Full Planning Applications: Flood Risk and Drainage Checklist

| SITE: | Land adjacent Martins Way, Ledbury |
| DESCRIPTION: | Erection of a 67-bed care home (with Class C2) parking access, landscaping and other associated works. |
| APPLICATION NO: | 190568 |

Extract of Existing Exceedance Routes drawing

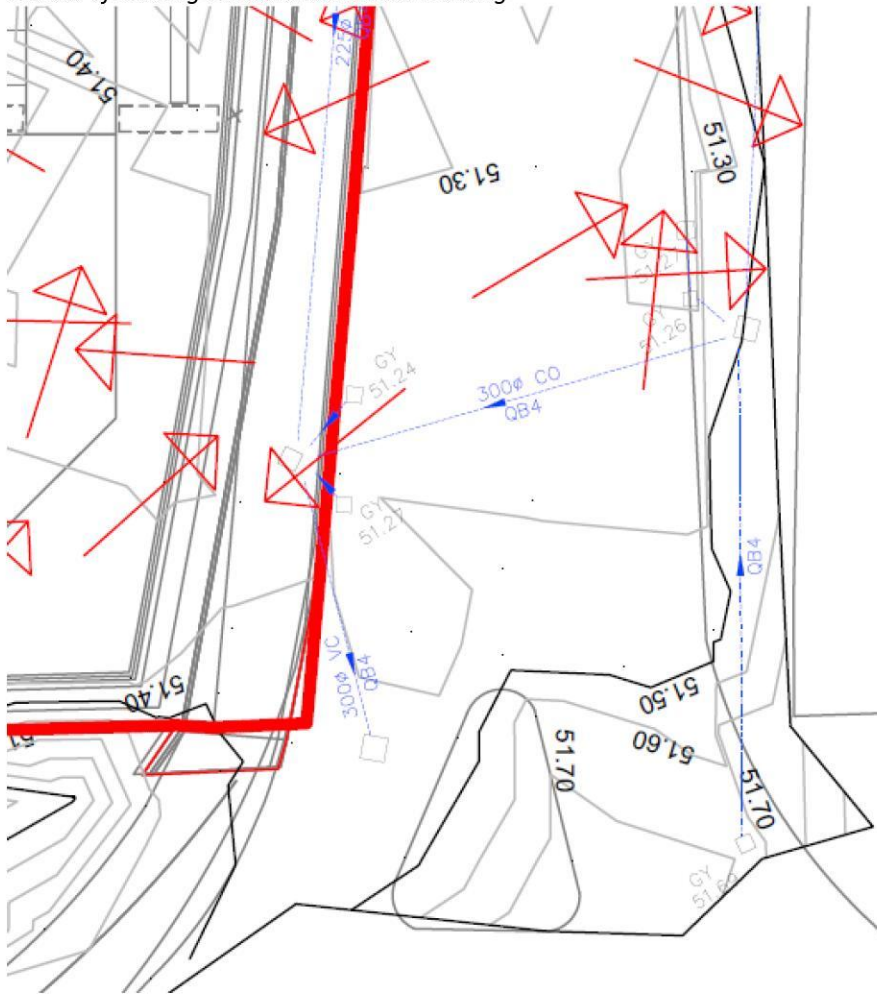
The Existing Exceedance Routes drawing (extract below) indicates that Martins Way is relatively flat but with a slight camber to both east and west road verges and a gentle fall towards the south. Our review of the plan also indicates, however, that levels in Martins Way increase slightly just before Leadon way, suggesting pooling of exceedance flows in this area. The Existing Exceedance Routes drawing indicates two gullies located at this low point. These will assist in managing exceedance flows from the west, although should these become blocked or overwhelmed, review of topography indicates that flood waters will flow west towards the site. This slight rise in levels at the junction between Martins Way and Leadon Way appears to have been picked up by the EA's surface water flood mapping. The applicant's engineer highlights that the EA's mapping would probably not pick up kerb heights, but the difference in levels between the lowest point in Martins Way and the level at the road junction is about 400mm, which is much more than the kerb height adjacent to the proposed site. The preferential (existing scenario) flow route for exceedance flows would therefore be to flow into the proposed site at this low point, rather than flow onto Leadon Way.

EA surface water flood risk map

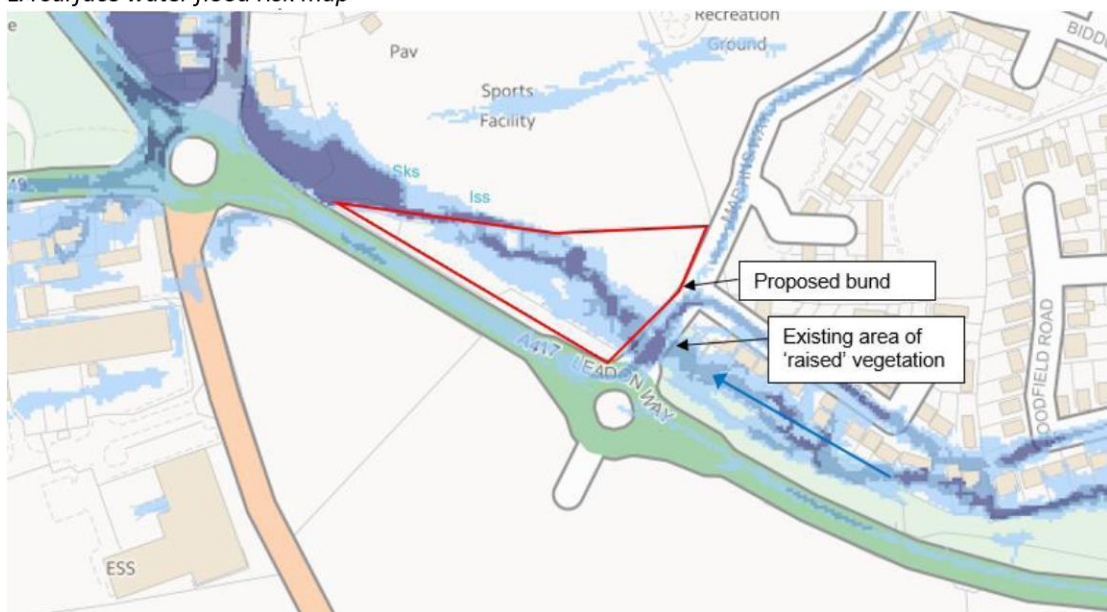
The applicant's engineer also states that ground to the east of the site adjacent to Martins Way (i.e. in the green space at the 'end' of the exceedance flow path through the rear gardens of existing properties) is raised and that this does not seem to have been taken into account in the EA's mapping. An extract of this raised area is provided below. The area appears to comprise dense vegetation and we agree that this is likely to reduce the flow of water towards Martins Way and encourage pooling of water behind the vegetation.
